Name: Corona Del Rey (El Corona/Patterson) – Rezone from RSF-5 to PR-6-Final Plat /Plan

PROJECT NARRATIVE AND IMPACT STATEMENT
FOR
MISSION VIEJO - A PLANNED UNIT DEVELOPMENT
(A REPLAT OF LOTS 1 THROUGH 10 INCLUSIVE
AND LOT 15 OF EL CORONA SUBDIVISION)
CITY OF GRAND JUNCTION, MESA COUNTY, COLORADO

REVIEW SHEET SUMMARY

Rezone from RSF-5 to PR-6 and a Final Plat & Plan for Mission Viejo

**MISSION VIEJO
DEVELOPMENT PLAN**
W.H. LIZER & ASSOCIATES
ENGINEERING & SURVEYING
576 25 ROAD - UNIT 8 - 241-1129
GRAND JUNCTION, COLORADO 81505

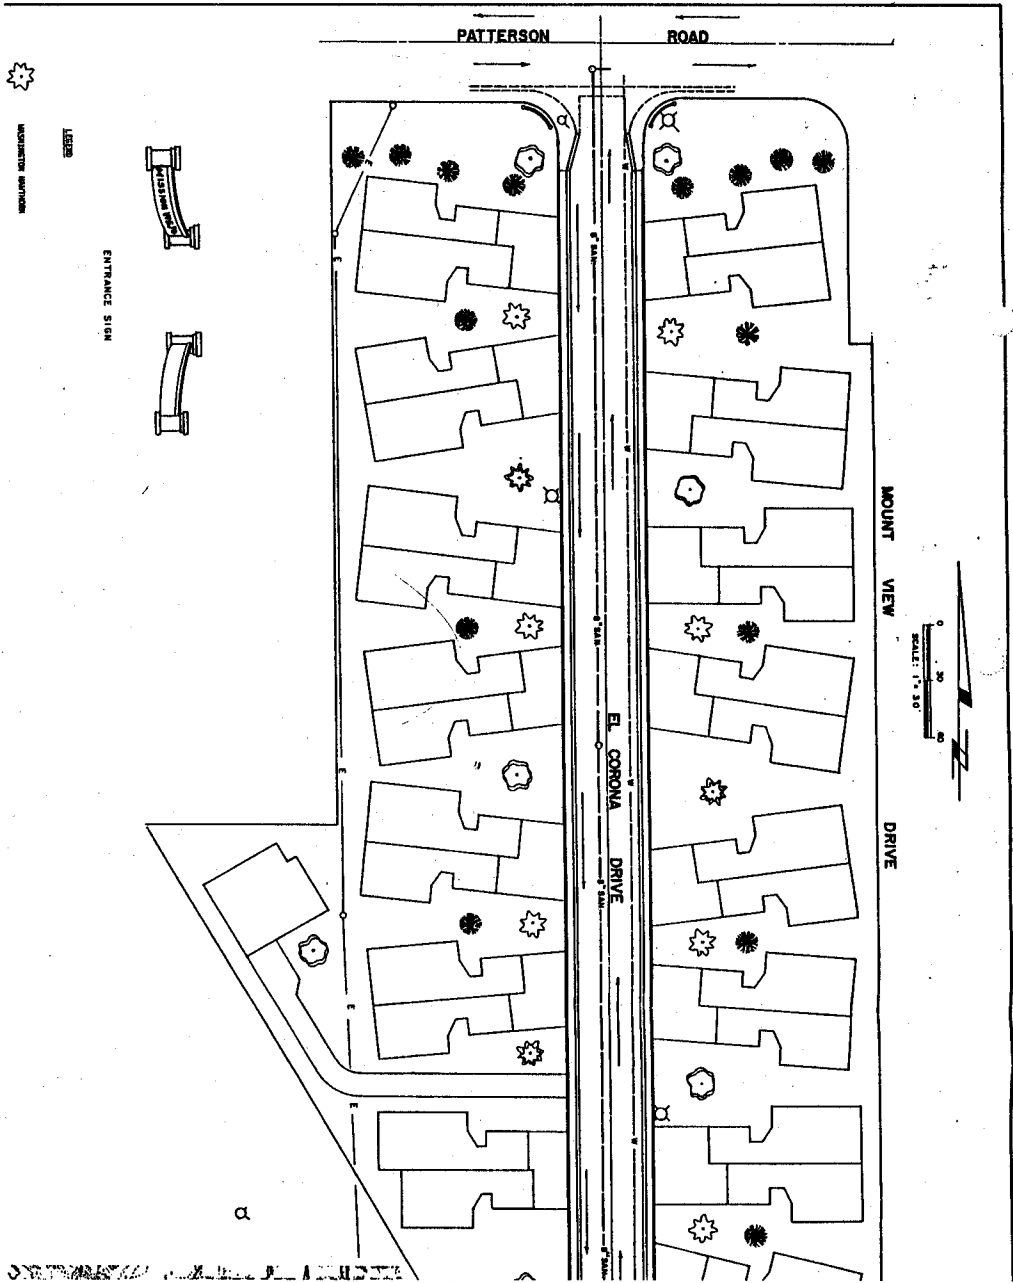
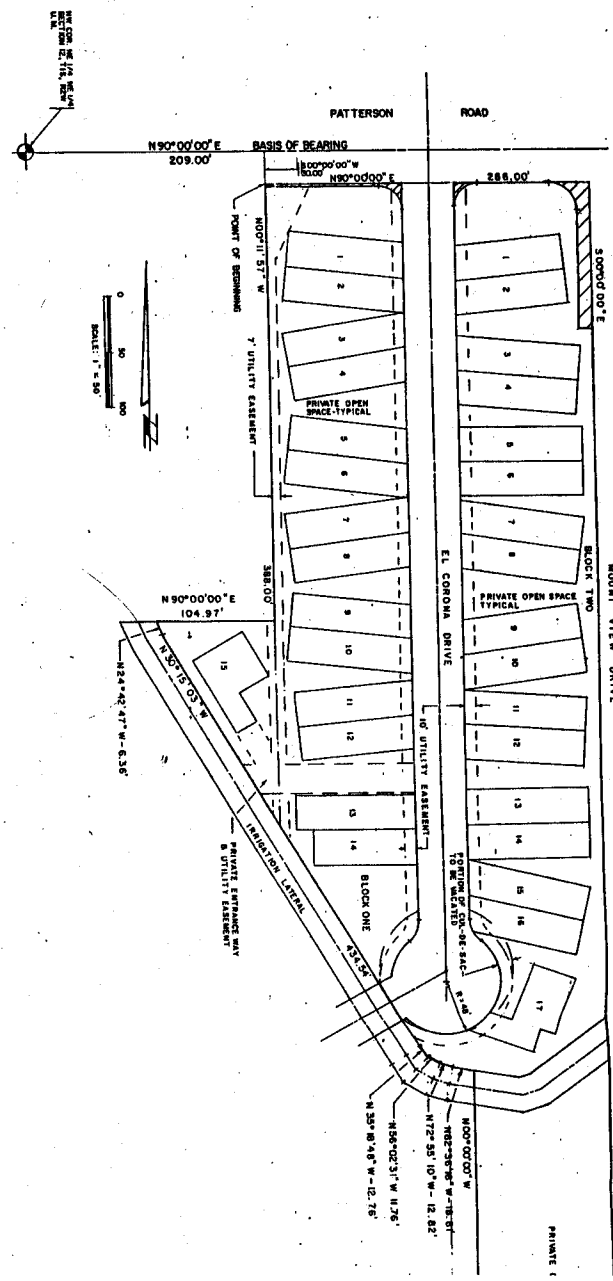
DEVELOPMENT PLAN

3. Show size of existing water line.
4. Provide street profile showing existing ground lines and street grade at center line and/or back of walk on each side. Show tie in elevations at Patterson Road.

5. Show street typical section including cross slopes, pavement section, R.O.W. width, street widths, etc. (Provide pavement design calcs.)
6. Provide drainage calculations and report addressing runoff volumes, detention facilities, effect on down stream facilities, etc.

7. Show construction bench mark.
8. Place statement on plans that all construction shall be in accordance with City of Grand Junction standards and specifications.

9. Show location of existing or proposed stop sign at Patterson Road.
10. Provide turn around at Lot 15.
11. Show proposed sewer and water tap locations.

Development Plan

1. See item 7 above on "Plat".
2. Sidewalks - Monolithic Pour: The sidewalks and curb and gutter section will be constructed with the street including installing the sidewalk to center of curb radii on Patterson Road. This is shown on the Street Plans which have been submitted to the City Engineer.
3. The size of the existing water line is shown on the Utility Composite which has been submitted.
4. Street Plans have been submitted showing tie-in to Patterson Rd.
5. Street section with cross slopes, pavement section, and pavement design calculations have been submitted.
6. Drainage calculations with retention basin data have been submitted.
7. Construction bench mark is shown on Street Plans which have been submitted.

8. Statement regarding construction to be done in accordance to City of Grand Junction Standards and Specs is shown on Street Plans which have been submitted.
9. Location of stop sign is shown on Development Plan which has been submitted.
10. Turn around for Lot 15 - shown on Development Plan which has been submitted.
11. Proposed sewer and water tap locations are shown on the Utility Composite which has been submitted.
